GC0127 / GC0128

LEGAL TEXT – DATED 02/12/2019

Housekeeping amendments directed by GCRP on 28 November 2019

Figure ECC.6.3.3(a) Active Power Output with falling frequency for **Power Generating Modules** and **HVDC Systems** and **Electricity Storage Modules** when operating in an exporting mode of operation

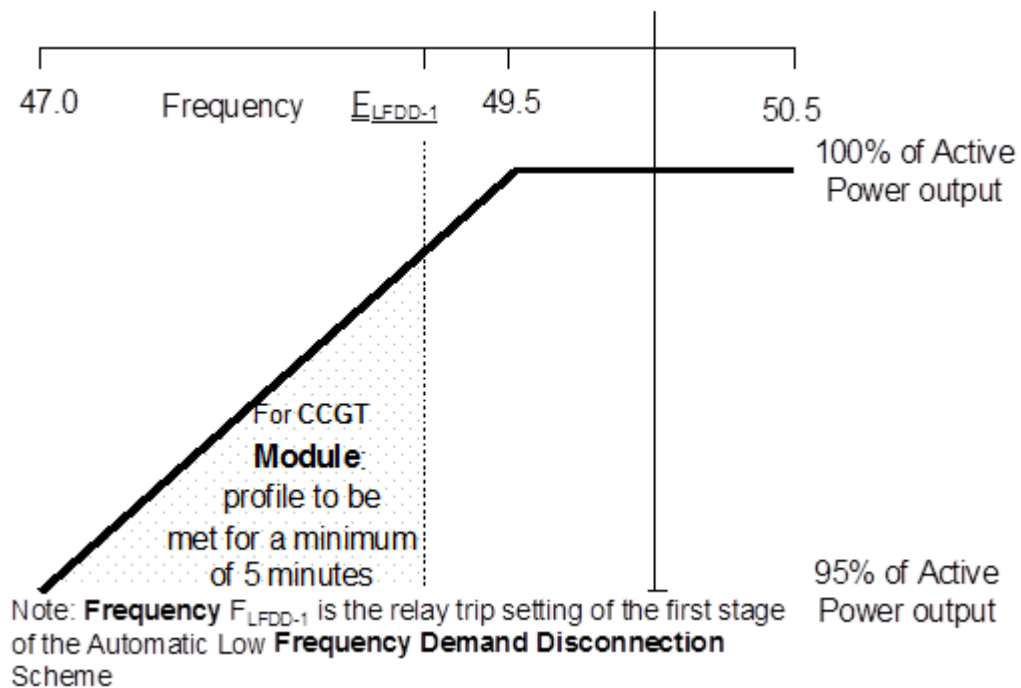
- (a) continuously maintaining constant **Active Power** output for **System Frequency** changes within the range 50.5 to 49.5 Hz; and
- (b) (subject to the provisions of ECC.6.1.2) maintaining its **Active Power** output at a level not lower than the figure determined by the linear relationship shown in Figure ECC.6.3.3(a) for **System Frequency** changes within the range 49.5 to 47 Hz for all ambient temperatures up to and including 25°C, such that if the **System Frequency** drops to 47 Hz the **Active Power** output does not decrease by more than 5%. In the case of a **CCGT Module**, the above requirement shall be retained down to the **Low Frequency Relay** trip setting of 48.8 Hz, which reflects the first stage of the Automatic Low **Frequency Demand Disconnection** scheme notified to **Network Operators** under OC6.6.2. For **System Frequency** below that setting, the existing requirement shall be retained for a minimum period of 5 minutes while **System Frequency** remains below that setting, and special measure(s) that may be required to meet this requirement shall be kept in service during this period. After that 5 minutes period, if **System Frequency** remains below that setting, the special measure(s) must be discontinued if there is a materially increased risk of the **Gas Turbine** tripping. The need for special measure(s) is linked to the inherent **Gas Turbine Active Power** output reduction caused by reduced shaft speed due to falling **System Frequency**. Where the need for special measures is identified in order to maintain output in line with the level identified in Figure ECC.6.3.3(a) these measures should be still continued at ambient temperatures above 25°C maintaining as much of the **Active Power** achievable within the capability of the plant. For the avoidance of doubt, Generators in respect of Pumped Storage Plant and Electricity Storage Modules shall also be required to satisfy the requirements of OC6.6.6.
